Sundry Print Report

Well Name: ADELINE ALN FED Well Location: T24S / R31E / SEC 6 / County or Parish/State: EDDY /

Type of Action: Plug and Abandonment

Adeline ALN Fed 11 2839562 PROCEDURE AND COA 20250319131344.pdf

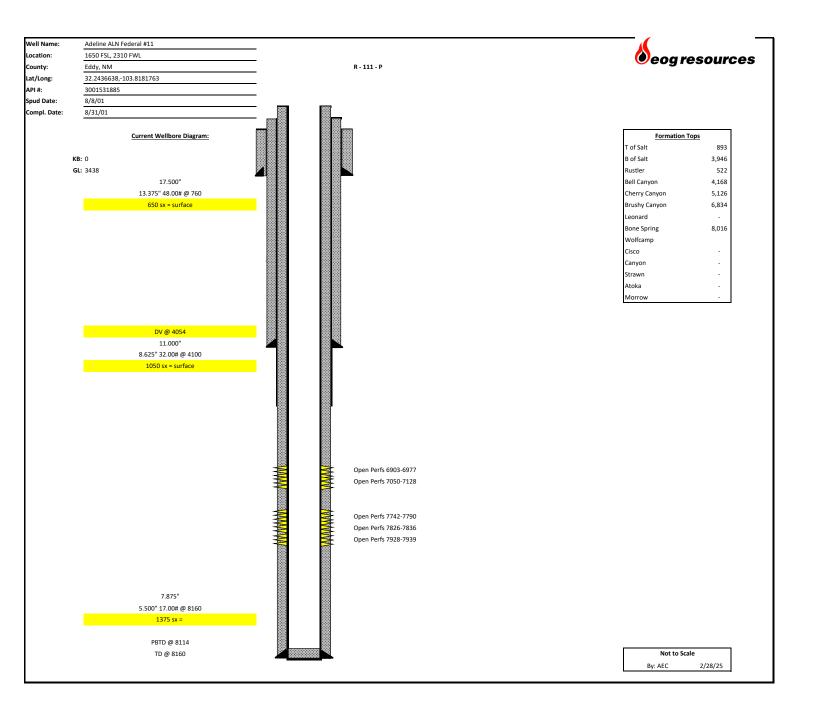
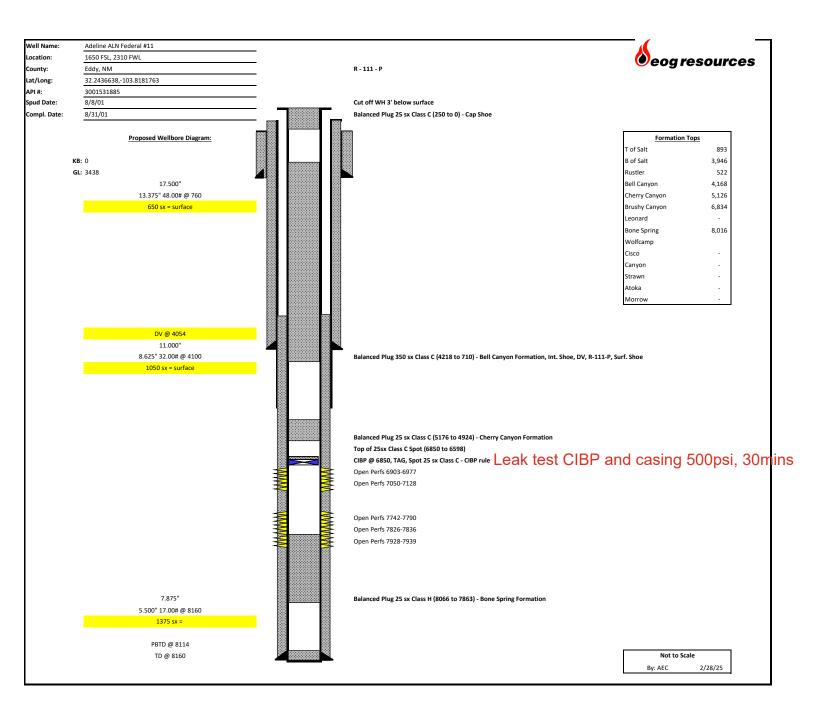
- 4. RIH, set balanced plug w/ 25sx Class H from 8066 to 7863 for Bone Spring formation.
- 5. RIH to set CIBP at 6850, TAG, and pressure test at 500 psi for 30-minute bubble test. Please identify any casing leaks and take remedial measures if necessary
